The Arcade and 18-20 Corporation Street and 17 Foundry Street, Dewsbury

Summary of Amendments

Doc No. 1705-BDP-AD-XX-RG-Z-00005
Revision: P01
Date: 18 June 2026

1 Second Floor Plan_Proposed
1:100

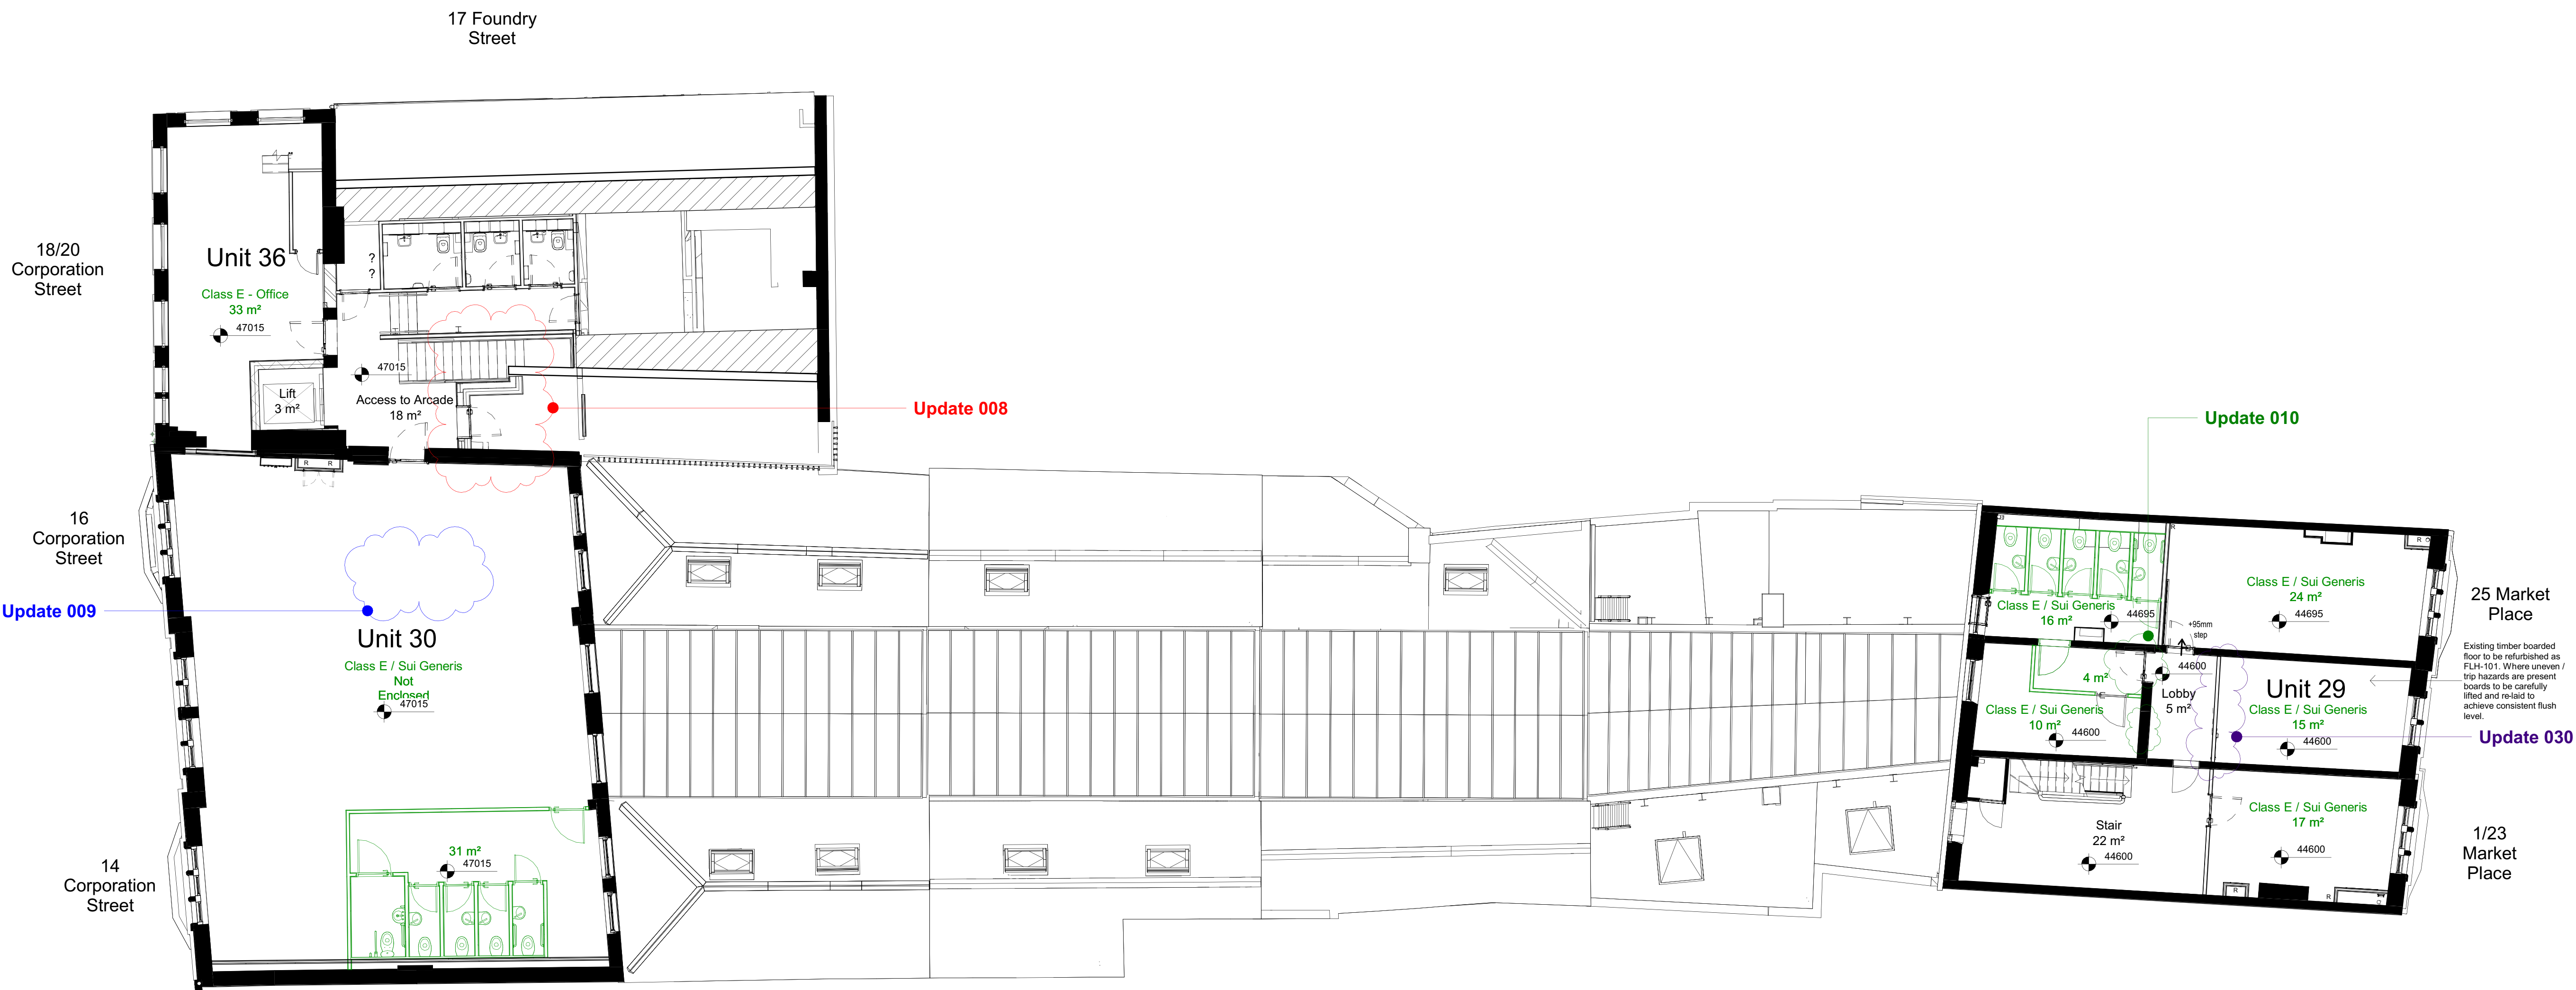
030	23-25 Market Place Units 28 and 29	Walls	Repair damaged masonry walls and replace plaster finish where irreparably damaged.	The walls were found to be a mixture of timber framing and unbonded masonry.	The walls were structurally unstable, and moved visibly when pushed.	Remove structurally unstable parts of walls and replace with new stud wall.	1705-BDP-AD-01-PL-A-20001_T01 1705-BDP-AD-01-PL-A-20002_T01 1705-BDP-AD-02-PL-A-20001_T01 1705-BDP-AD-02-PL-A-20002_T01	1705-BDP-AD-01-PL-A-20001_T02 1705-BDP-AD-01-PL-A-20002_T02 1705-BDP-AD-02-PL-A-20001_T02 1705-BDP-AD-02-PL-A-20002_T02

1 Second Floor Removals Plan

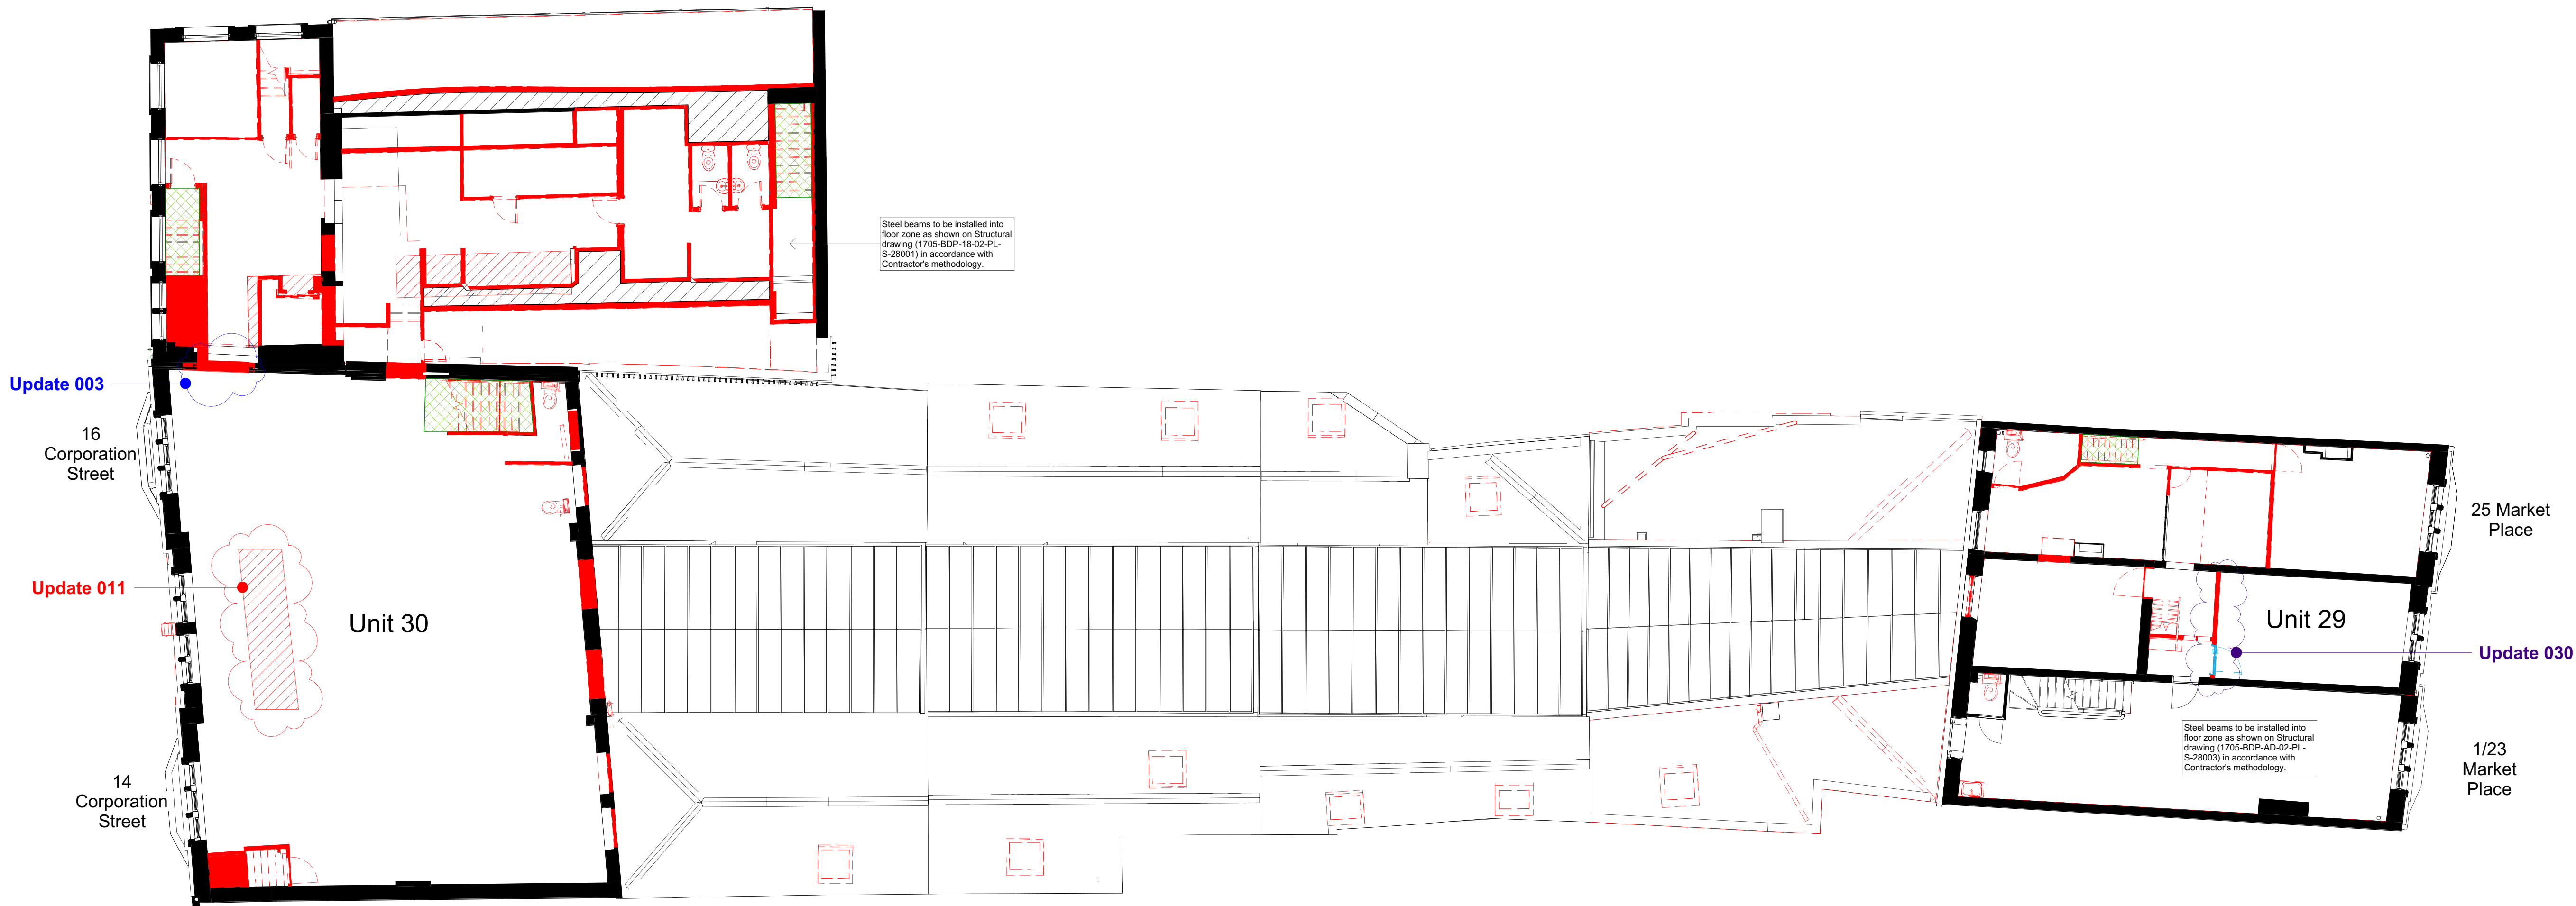
002	25 Market Place Unit 2	Internal partitions	At ground floor, the stair would exit into unit 2.	n/a	For building regulations and fire evacuation, it is necessary for the stair exit to be separated from unit 2.	Minor change to internal layout with new partition added to separate the stair exit from unit 2.	1705-BDP-AD-00-PL-A-20001_T01 1705-BDP-AD-SL-PL-Z-00003_T01	1705-BDP-AD-00-PL-A-20001_T02 1705-BDP-AD-SL-PL-A-00003_T02
003	23-25 Market Place and 14-16 Corporation Street	Masonry walls	Existing wall to be retained.	Following the removal of modern finishes (e.g. plasterboard), several sections of wall have been found to be recent blockwork.	These blockwork infills are mostly poorly built, not meeting the fire performance requirements or modern structural requirements.	Replace poor quality blockwork infills with new, to meet modern requirements.	1705-BDP-AD-00-PL-A-20002_T01 1705-BDP-AD-02-PL-A-20002_T01	1705-BDP-AD-00-PL-A-20002_T02 1705-BDP-AD-02-PL-A-20002_T02

1 Third Floor Removals Plan

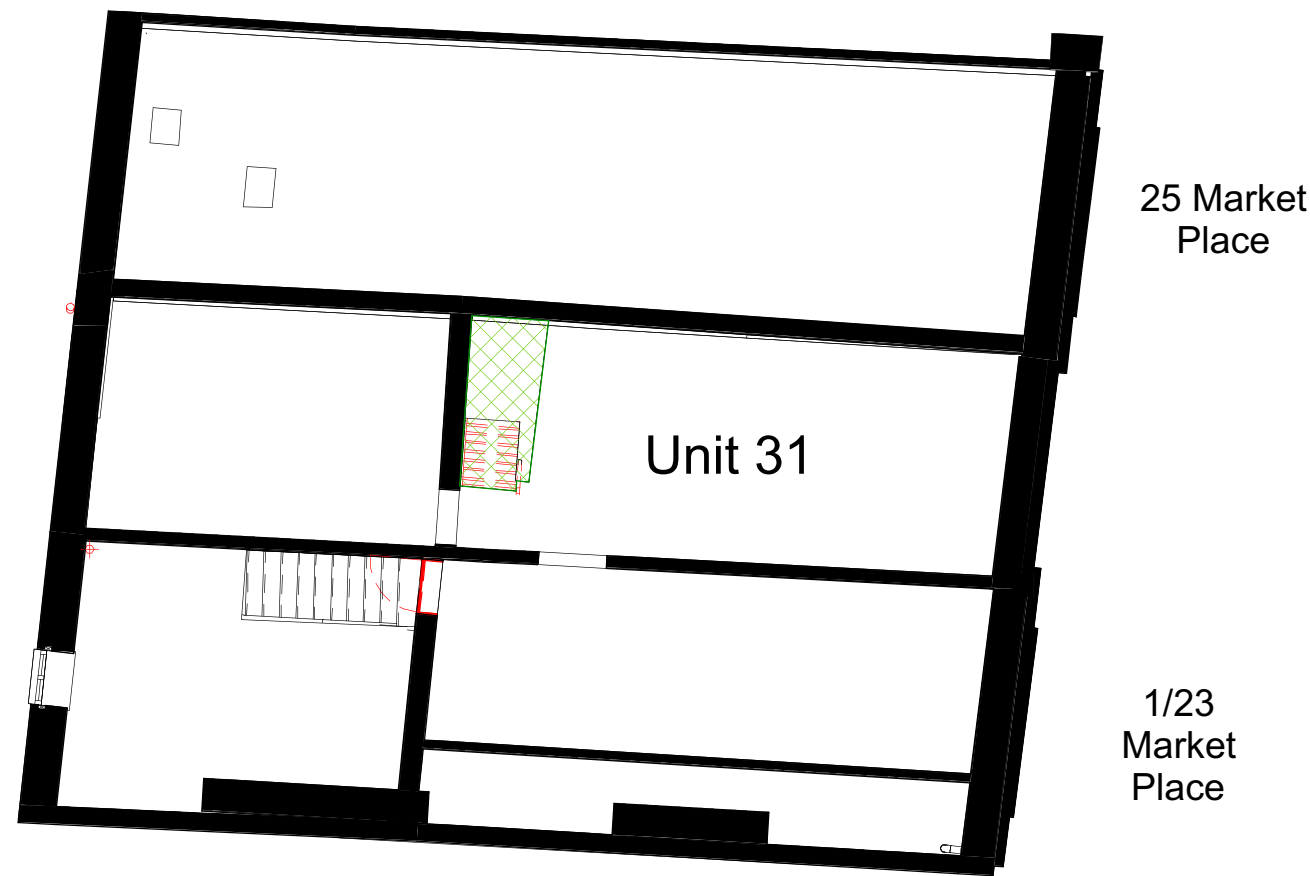
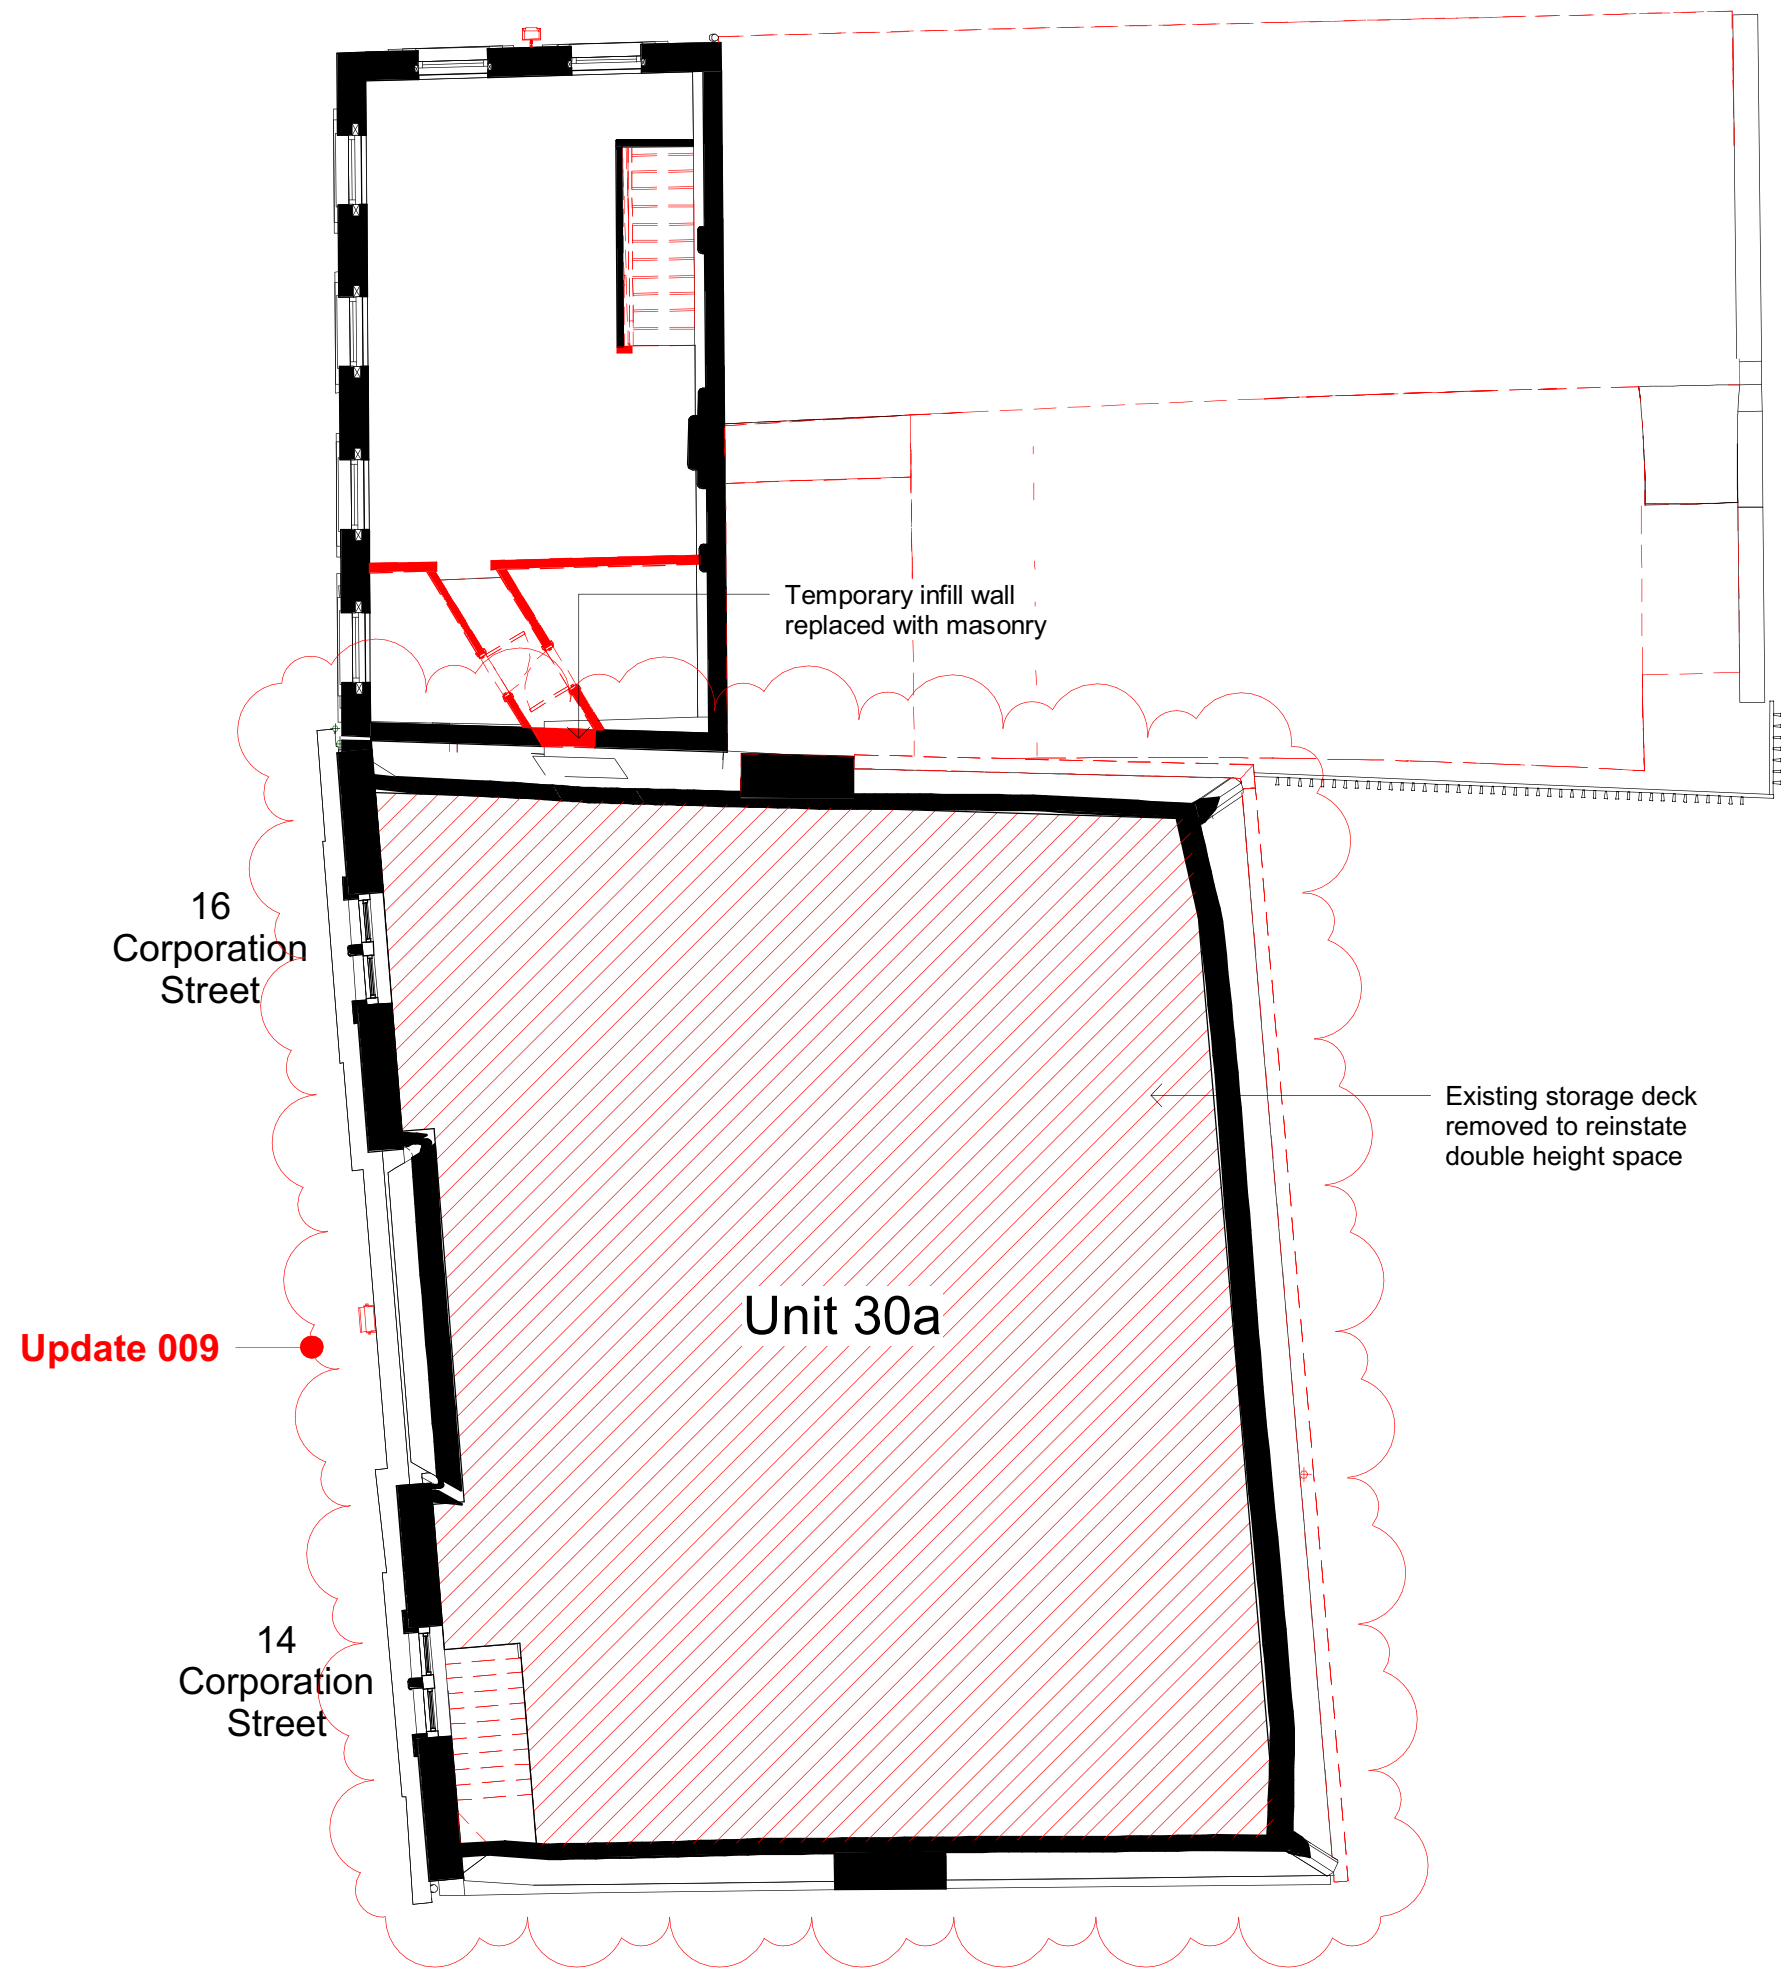
009	14-16 Corporation Street Unit 30 / Unit 30a	Storage deck	Repair the existing timber joisted storage deck above unit 30 (forming a storage area known as unit 30a). Remove the permanent stair, and provide an access hatch and sliding ladder.	Accessing this storage area (which was previously unsafe to access) has revealed that the pattern painted onto the bottom chords of the trusses visible in unit 30 continues onto the rest of these queenpost trusses (the principal rafters and struts). The original archive construction drawings also do not show a storage deck in this location. Because of this, and closer inspection of the structure of the storage deck, it is now believed that this deck is not original to the building.	Opportunity to return part of the building to its earlier configuration, improving the spatial quality of this room which was originally constructed as a workshop for the stores below.	Remove this storage deck to return the space to its original configuration. Omit the ladder and access hatch previously proposed.	1705-BDP-AD-02-PL-A-20001_T01 1705-BDP-AD-03-PL-A-20001_T01 1705-BDP-AD-03-PL-A-20002_T01	1705-BDP-AD-02-PL-A-20001_T02 1705-BDP-AD-03-PL-A-20001_T02 1705-BDP-AD-03-PL-A-20002_T02
